## LB-8 MAGNET VALVE PORTIONS

### Transient Voltage Suppressor Upgrade

NOVEMBER, 1997

**Figure 1 - LB-8 Magnet Valve Portion with Transient Voltage Suppressor**

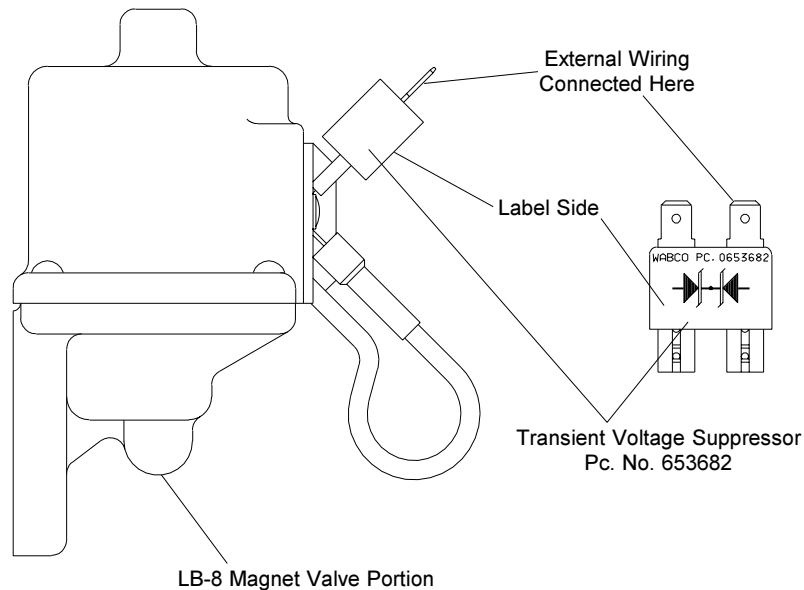
Wabtec has developed an improved **Transient Voltage Suppressor, Pc. No. 653682**, for use on the LB-8 Magnet Valve Portions. This new device is being issued as an alternate standard, and can be substituted in place of standard suppression diode, Pc. No. 303894, where a higher level of protection against voltage transients is desired.

Figure 1 depicts proper installation of the Wabtec Transient Voltage Suppressor to the LB-8 Magnet Valve Portion.
